Old Conway Design
Overlay District

DESIGN REVIEW BOARD MEETING

Old Conway Design Overlay Review

Central Baptist College Parking Lot Review

Proposed New
Parking Area

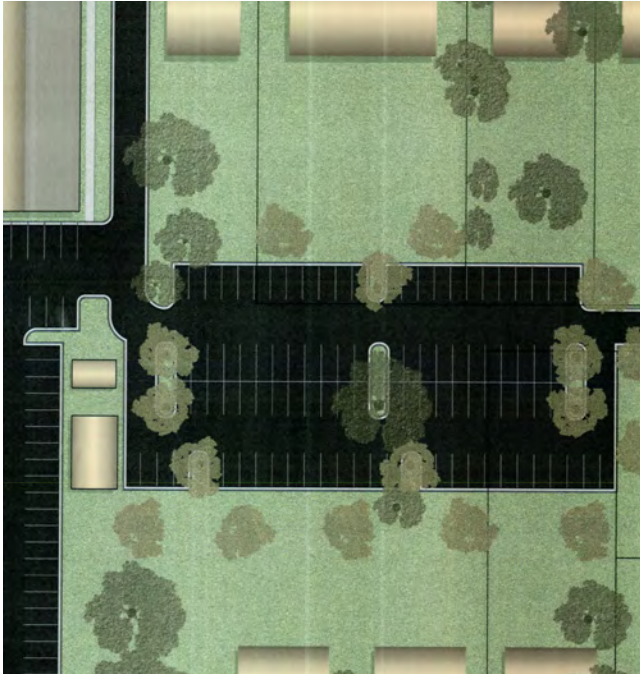
As stated in the Old Conway Design Guidelines, parking is essential to the success of any street, but negative ramifications to the pedestrian environment should be mitigated. The most important aspect to the creation of a desirable parking area is careful consideration for an appropriate location. If a parking area must be located in a less desirable area, walls and landscaping should be used for screening. Another important consideration is careful placement of driveways and curb cuts. **The proposed location is an interior area of the campus and as such, appears to be an appropriate location.**

Tree preservation: The OCDOD ordinance requires that any significant trees over 8 inches in diameter be preserved. It appears that there are 3 trees affected by the proposed parking lot. It also appears that through careful placement of the parking lot curbs and islands, that a good attempt is being made to preserve these trees.

Lighting: Any new lighting should be inward, downward, and shrouded so as to stay within the bounds of the property. No light fixtures are shown on the supplied drawings.

1. Parking location shall be generally as shown on the submitted site plan.
2. Parking lot shall be constructed generally as shown on the submitted site plan.
3. Plans shall reflect the preservation of existing trees and best tree preservation practices shall be used during construction.
